RE: Application for Amendment to Water Use Licence NWB5QIK0207

UMA Engineering Ltd. is submitting an application for an amendment to the above-noted water use licence for the clean up of the FOX-5 DEW Line Site. The application is being submitted on behalf of Defence Construction Canada (DCC) and the Department of National Defence.

The work being undertaken is part of the overall cleanup of the FOX-5 DEW Line site, under current water use licence number NWB5QIK0207. The amendment includes the construction of two landfarms for the treatment and remediation of hydrocarbon contaminated soils and the relocation of a landfill in the middle site area. Please see the attached drawings for locations.

**RE: Screening Decision 01DN004 for the Clean Up of FOX-5, Broughton Island
DEW Line Site**

DATE: 2003-01-14
SUBJECT: T-141
PROJECT LAYOUT

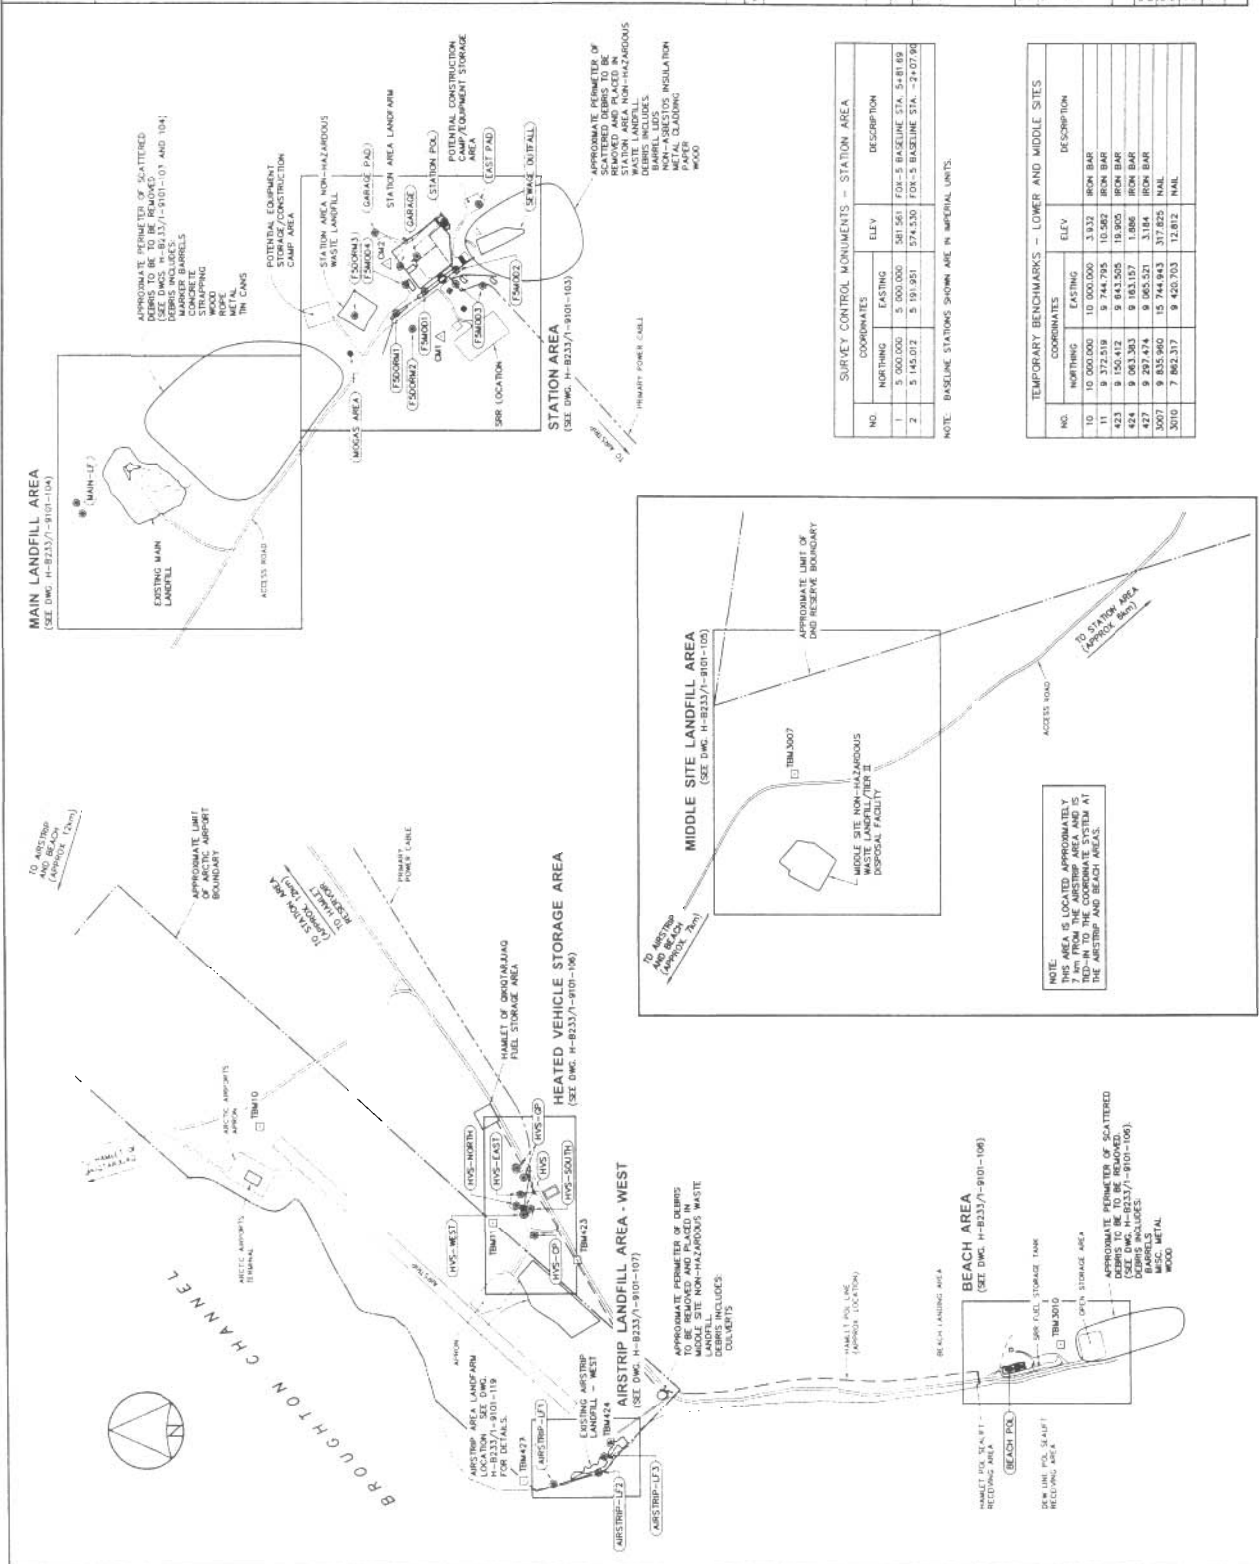
The second amendment to the October 2000 NIRB submission is the construction of two landfarms for the remediation of hydrocarbon-impacted soils. One landfarm is at the Airstrip Area and one landfarm is at the Station Area, where the majority of the hydrocarbon impacted soils are located. Because of the distance between these locations, and the very poor condition of the road to the Station Area, it was determined that two landfarm areas would be required. The locations of the landfarms are shown on Drawing 102.

ENC. NO. - DESIGN NO.
H-8233/7-8101-105

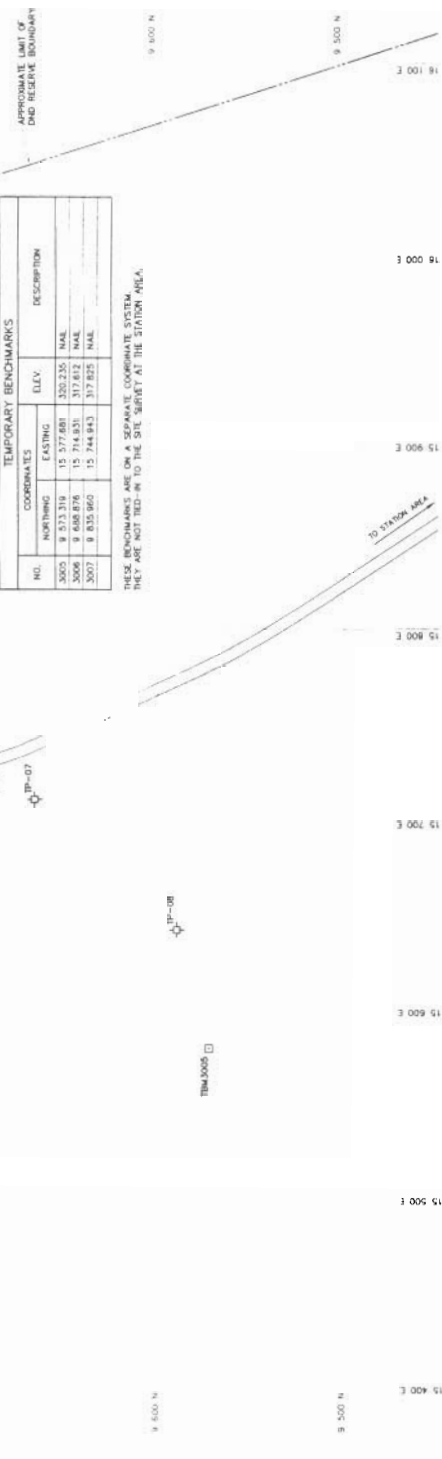
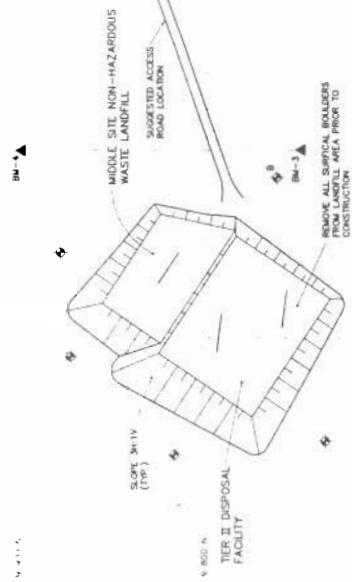
The last amendment refers to the location of the Tier II Soil Disposal Facility and Non-Hazardous Waste Landfill. Based on discussions with the Hamlet of Qikiqtarjuaq, additional locations for these landfills were investigated in September 2002. The final location, called Landfill N, was chosen based on both environmental and engineering suitability. Landfill N is located at the middle site between the main station and the community (Drawings 101, 105, 116-118).

The area is at the top of a pass approximately 30 m south of the station road. Drainage from the area flows west down towards the community landfill approximately 3 km west of the area. Ultimately, the drainage flows to the ocean approximately 4 km from the proposed site.

The area is undisturbed ground with soils consisting of sand with sorted gravel, cobble and boulder strands. The area north and south of the proposed landfill area contains more and larger boulders. Vegetation consists of mosses and a small amount of grasses. The area slopes to the west at a grade of 6%.

AIRSTRIIP AREA LANDFARM
PLAN AND CROSS SECTION[illegible]

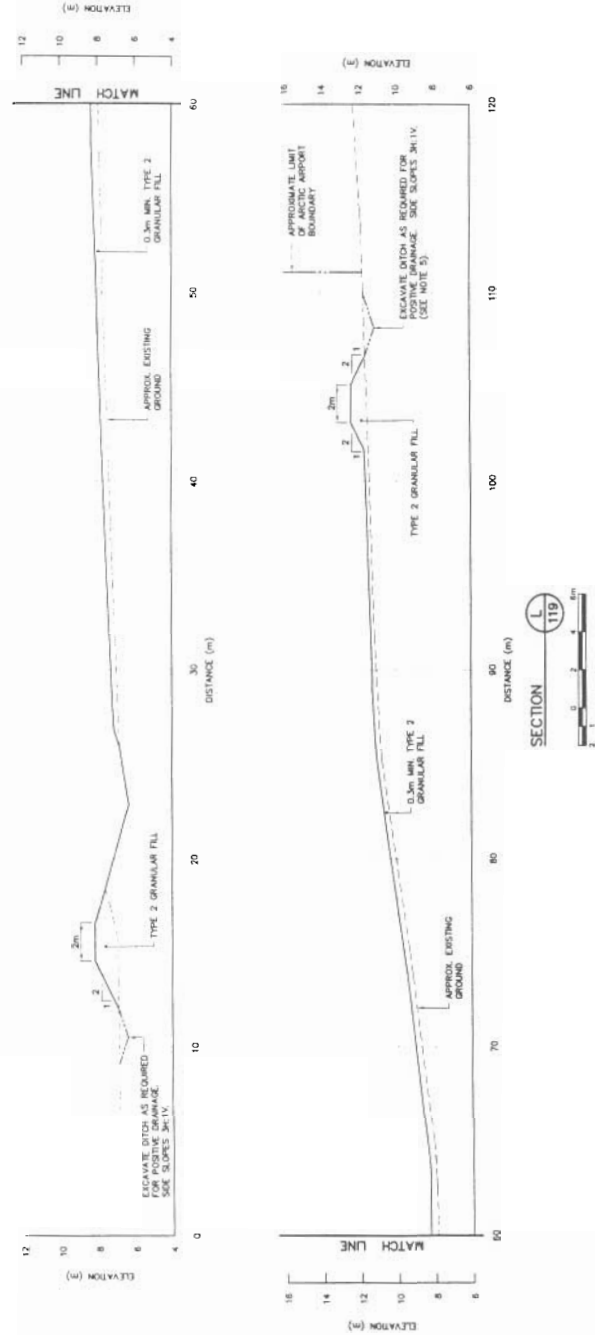
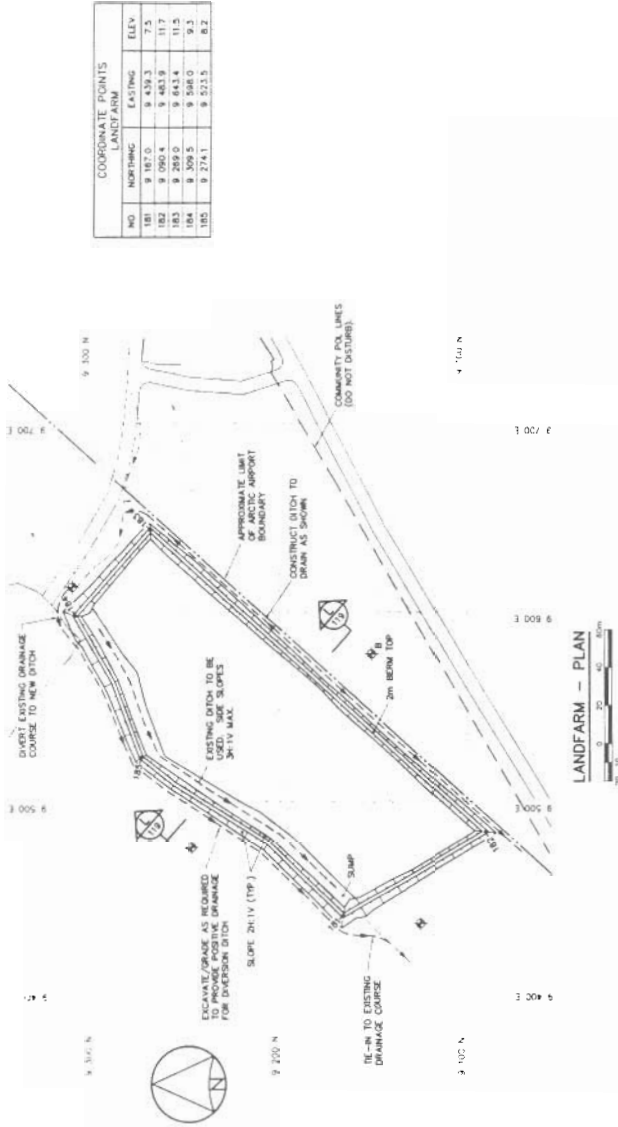
The first proposed landfarm site is located just west of the Heated Vehicle Storage area at the Airstrip Area near the Heated Vehicle Storage (HVS), south of the community airstrip (Drawings 102, 106 and 119) on property currently owned by Nunavut Airports. The soil is predominantly a medium sand with trace gravel in the profile and some gravel and small cobbles at the surface. The topography slopes gradually towards the northwest boundary of the landfarm and is bisected by a number of small drainage channels. A larger drainage channel running along the northwestern, downgradient edge of the landfarm collects drainage from the road and HVS area above the landfarm. The only debris in the area consists of one barrel half-buried in the drainage ditch near the middle of the landfarm length.
